Replacing the cable track in the unload pan

Cable in the flex track rotator assembly wears out prematurely. An improved cable is available. (FCO E876)

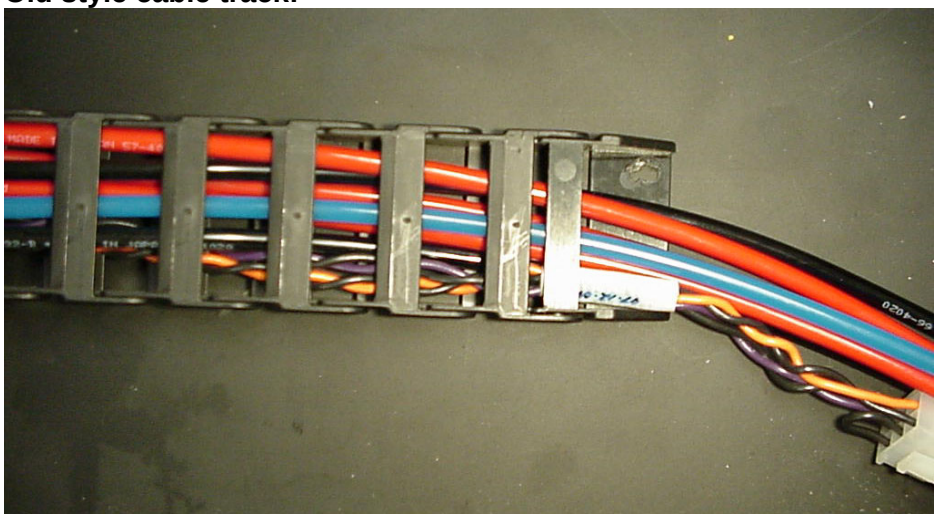
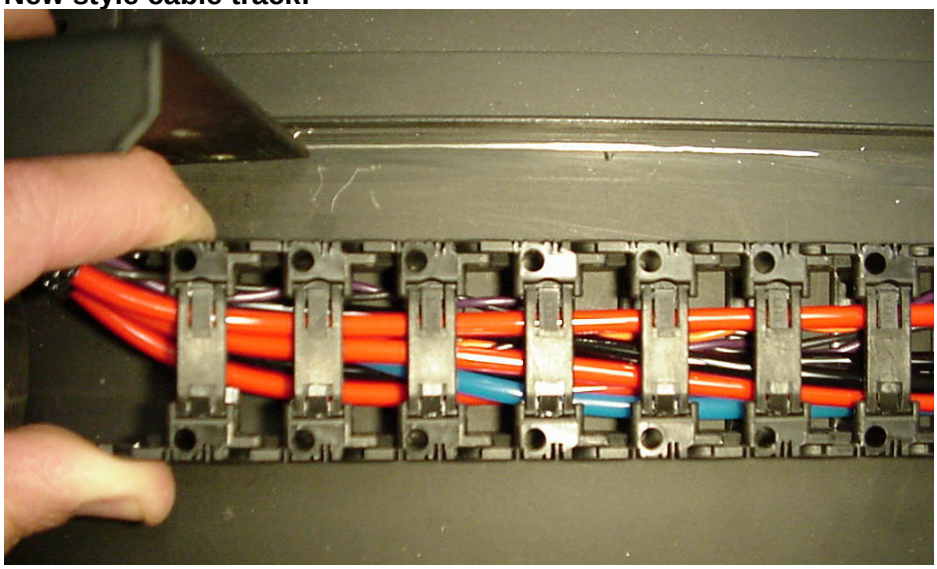
Old style cable track:

New style cable track:

- Kit # 05-0249 (rotator)
- Kit # 05-0250 (non-rotator)
- Both kits include adaptor brackets (58-0313) that are only needed for devices with older style cable tracks.

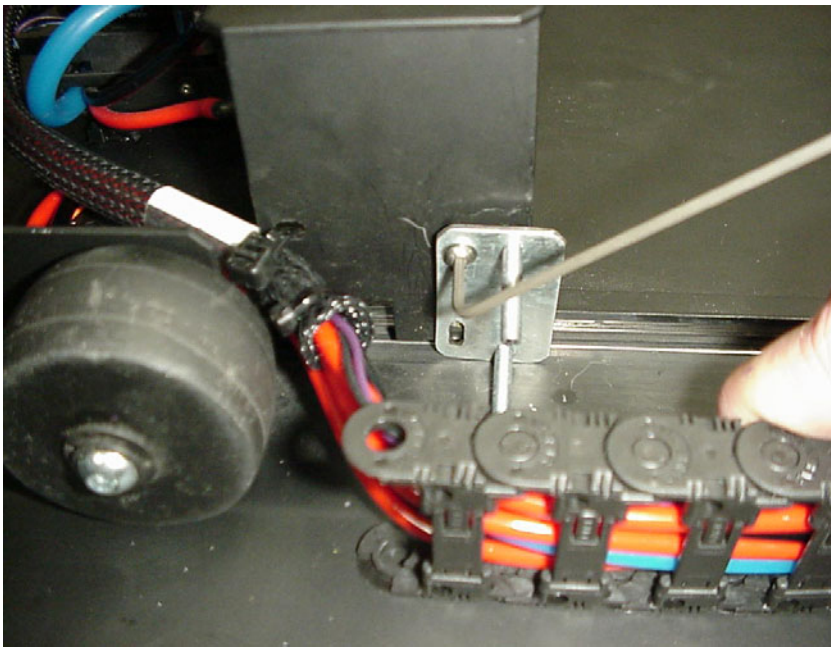
5. Attach the other cable track adaptor plate to the traveler making sure that the adaptor plate is not more than1-2mm from the bottom of the pan. See photo below. This will prevent the track from jumping over the guide rail.

Use the M3 screws and washers provided to attach the plate.
